Central Planning Authority

Agenda for a meeting of the Central Planning Authority to be held on **July 07, 2021 at 10:00am,**
in Conference Room 1038, 1st Floor, Government Administration Building, Elgin Avenue.

CPA/14/21

Figure 1. Dry forest and woodland and dry shrubland (yellow and green) are located on the southwestern part of the site (outlined in blue).

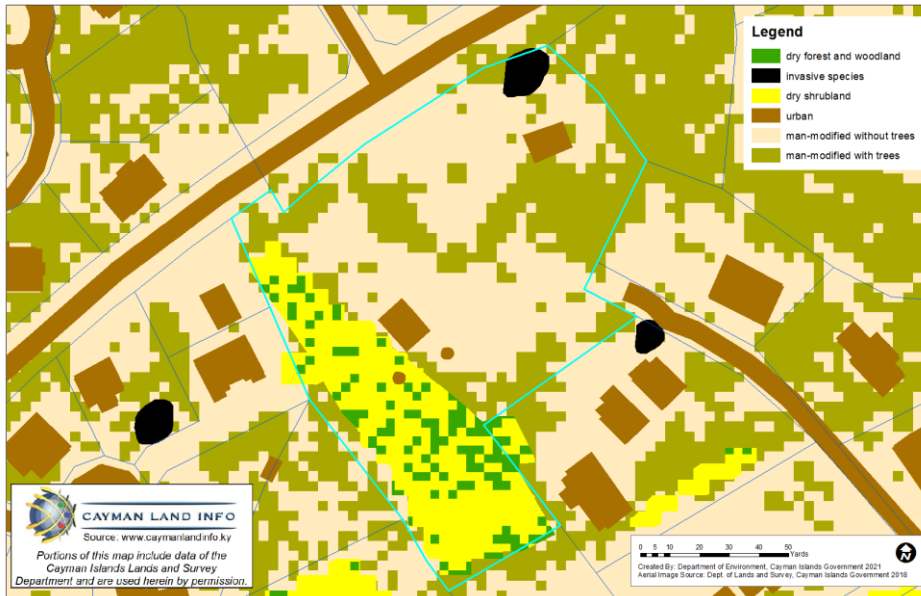
The south-western part of the site is dry forest and shrubland while the eastern part of the site is man-modified (see Figure 1). The dry forest and shrubland should be retained in the setbacks where possible. Native vegetation is best suited for the habitat conditions of the site, requiring less maintenance and making it a cost-effective and sustainable choice for landscaping.

Figure 1. The site (blue) and areas of sea turtle Critical Habitat (red) and sea turtle nesting beaches (yellow).

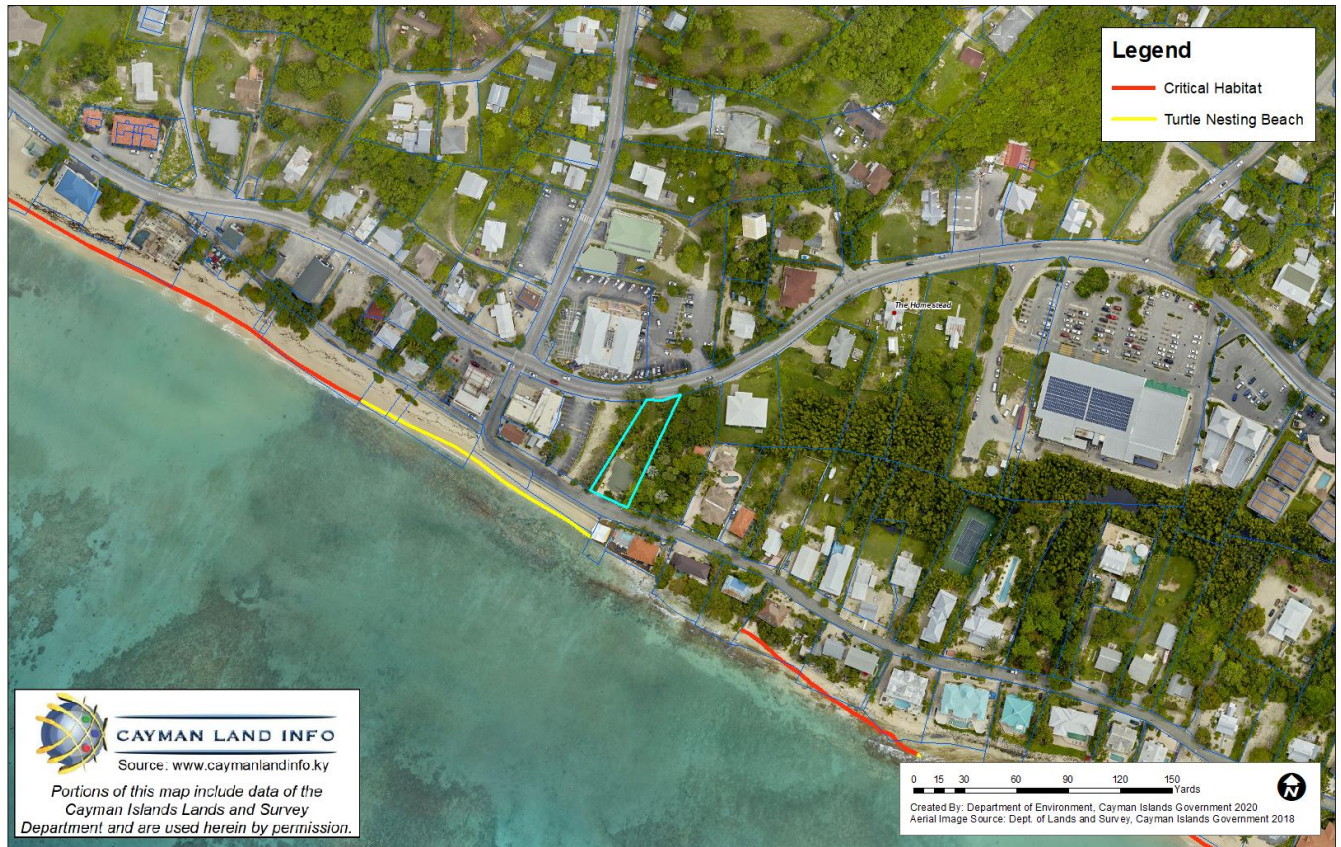
*The site is man-modified and of low ecological value. However, the beach at Boggy Sand Road, to the west of the site (across the street), is a turtle nesting beach (with Critical Habitat beyond to the north west) and the beach to the south east is Critical Habitat for turtle nesting (Critical Habitat is defined in the Interim Directive for the designation of Critical Habitat of Green turtles (*Chelonia mydas*), Loggerhead turtles (*Caretta caretta*), Hawksbill turtles (*Eretmochelys imbricata*), Leatherback turtles (*Dermochelys coriacea*) and all other species that may occur in Cayman waters including Kemp's Ridley turtles (*Lepidochelys kempii*) and hybrids (2020)). The areas of turtle nesting and Critical Habitat are shown in Figure 1 below.*

In addition, due to the scale, we recommend that a Turtle Friendly Lighting Plan is prepared which minimises the effect of artificial lighting on the nesting beach. Bright lights on the beach can deter female turtles from nesting and cause baby turtles to crawl away from the sea, where they often die from dehydration, exhaustion, predators or vehicles. It is important therefore that any lighting that may directly, indirectly or cumulatively illuminate the nesting beach be turtle friendly.

- 1) The applicant shall prepare and submit a plan to the Department of Environment for turtle friendly lighting, which minimises the impacts of artificial lighting on sea turtles. All lighting shall be installed in accordance with the plan, to be approved by the DoE. Guidance on developing a lighting plan can be found in the DoE's Turtle Friendly Lighting: Technical Advice Note (September 2018).*

Figure 1: DOE's 2013 Habitat Map Extract showing application site (outlined in blue)

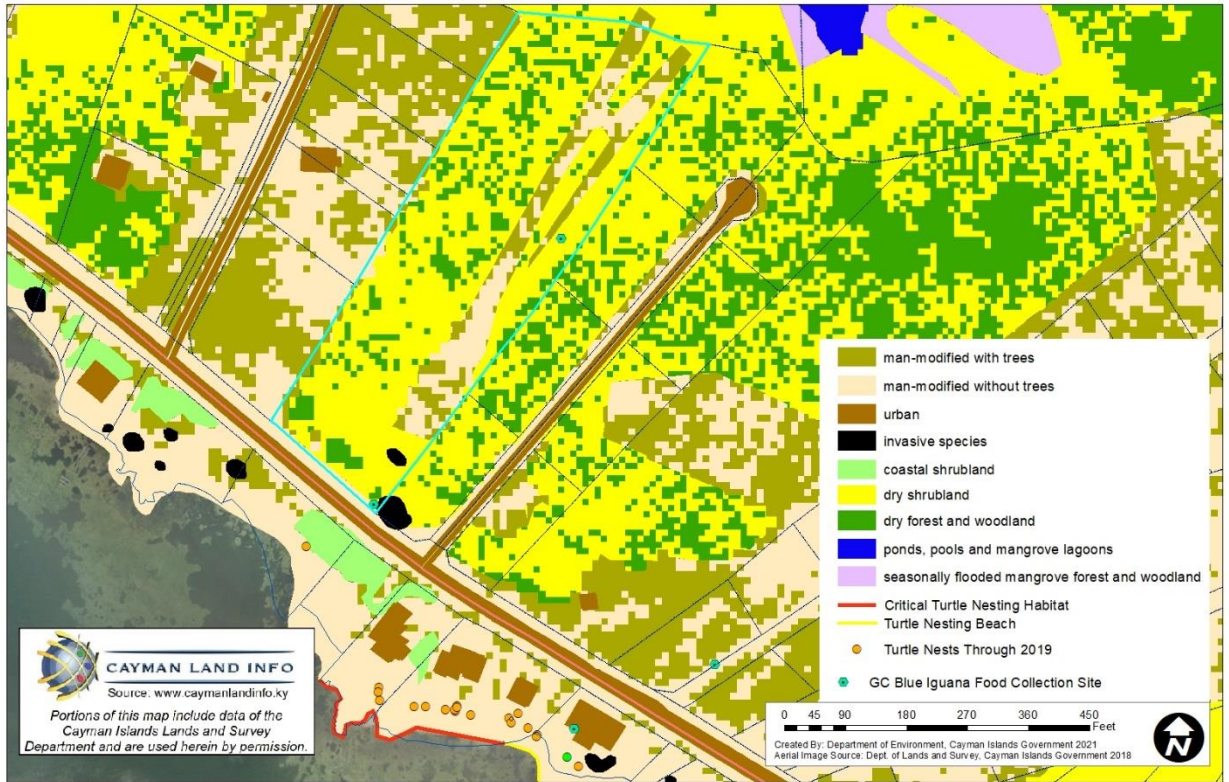
*The application site consists primarily of dry shrubland and forest with some limited areas that have been man-modified (See Figure 1), but has regrown with valuable secondary growth as shown in Figure 2. There are two locations on the parcel where food for the Blue Iguana Recovery Programme is collected by Blue Iguana Conservation staff (formerly Blue Iguana Recovery Programme). In addition, the site is located to the north-west an area designated as critical habitat for nesting sea turtles as defined in the Interim Directive for Green turtles, (*Chelonia mydas*), Loggerhead turtles (*Caretta caretta*), Hawksbill turtles (*Eretmochelys imbricata*) and all other species that may occur in Cayman Waters.*

Figure 3: Plan Extract Overlaid onto LIS 2018 Aerial Imagery showing location of Iguana Food Collection sites (Blue Dots) (Plan source: Jay Welcome March 2021; Aerial Imagery, Lands and Survey Department, 2018)

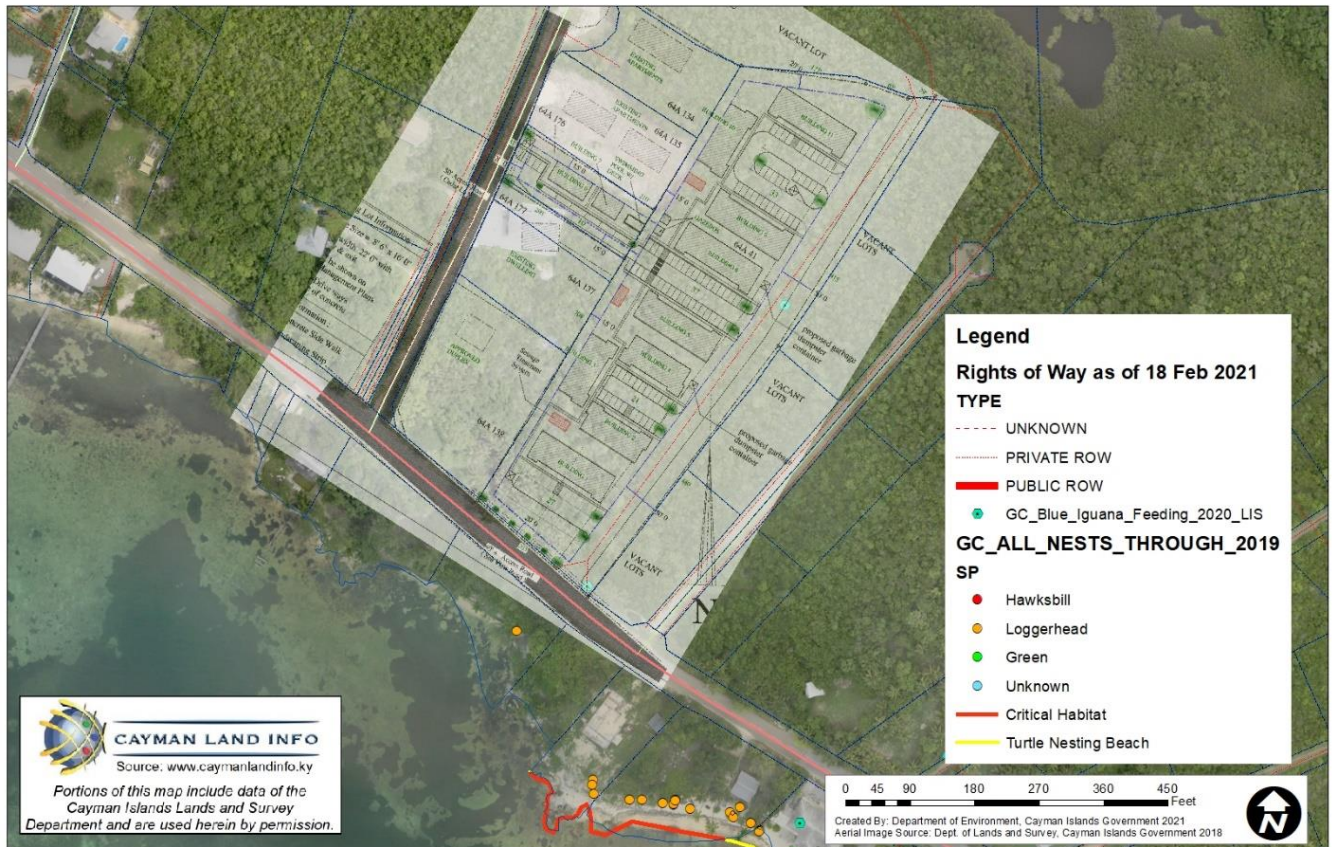
The application site has two locations where Blue Iguana food is collected. These collections spots are on the eastern boundary and east of the proposed development access road as shown in Figure 3. The DoE recommends that the vegetation along the road is retained to allow for the food collection sites to remain. This strip could also act a vegetated buffer between the development and the adjacent parcels.

- *A vegetated buffer strip should be left between the development access road and the eastern boundary to allow for the retention of Blue Iguana Recovery Programme food collection sites on the parcel. This vegetated buffer would also provide some privacy between the development and the adjacent parcels*
- *The natural ridge on site should remain as is. There shall be no excavation or mining of the ridge.*
- *The applicant should not include any floodlights or spotlights which are directed towards the turtle nesting beach.*

*Figure 4: Showing LIS Terrain Model of the application site's (outlined in blue) ridge
(Source:Lands and Survey Department)*

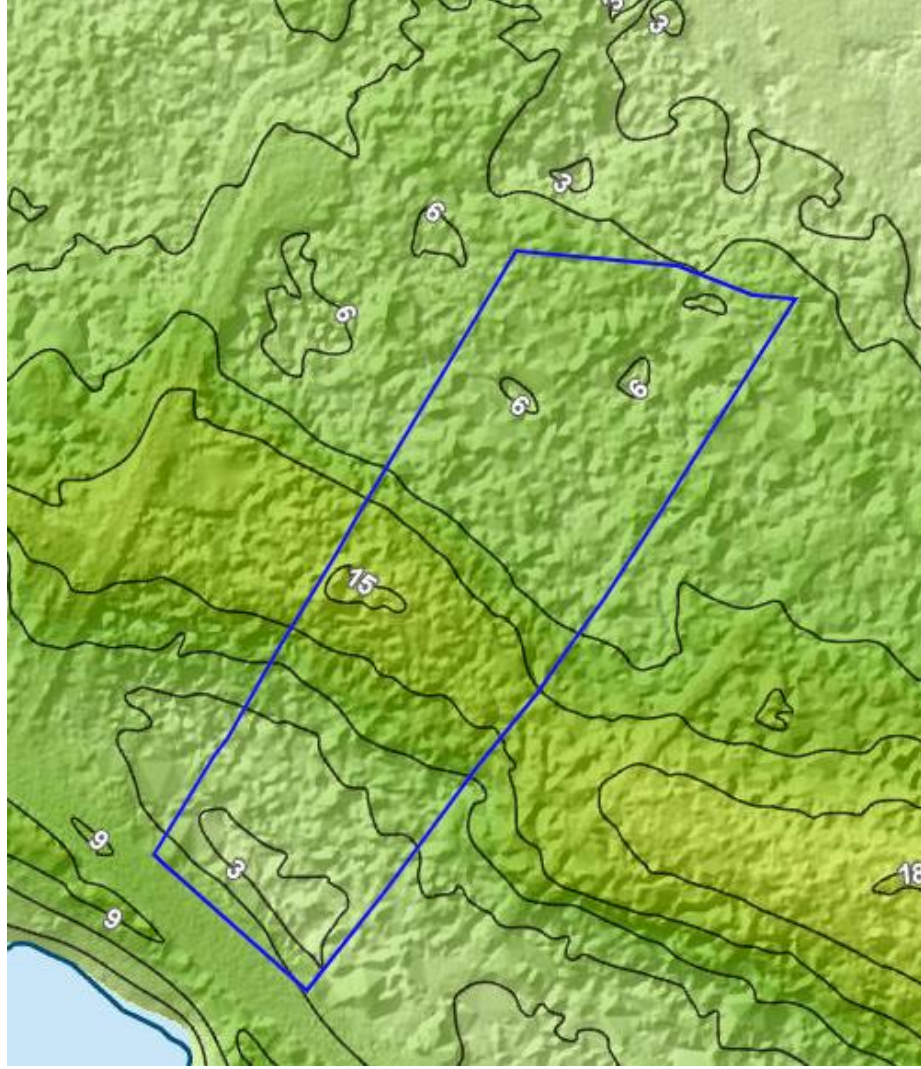
The terrain model as provided by the Lands and Survey Department (see Figure 4 and 5), indicates that there is a ridge in the center of the parcel that goes up to approximately 15 feet above mean sea level. The Department does not support any excavation or mining of the ridge. This geological feature of the site should remain and to be incorporated into the design of the development. It will assist with the resilience of the development to the impacts of climate change, including storm surge.

Figure 1: LIS 2018 Aerial Imagery Showing Application Site Outlined in Blue

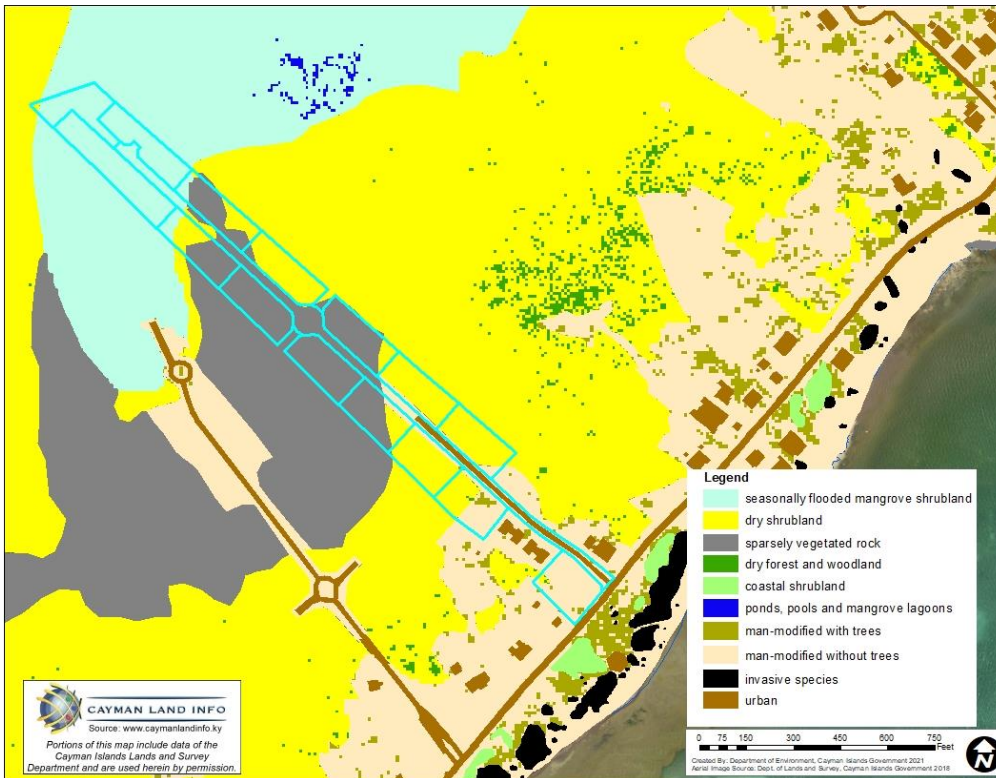
The application site consists of diverse primary habitats; seasonally flooded mangrove shrubland, dry shrubland, sparsely vegetated rock along with some areas that have been man-modified and have secondary growth, as shown in Figure 1.
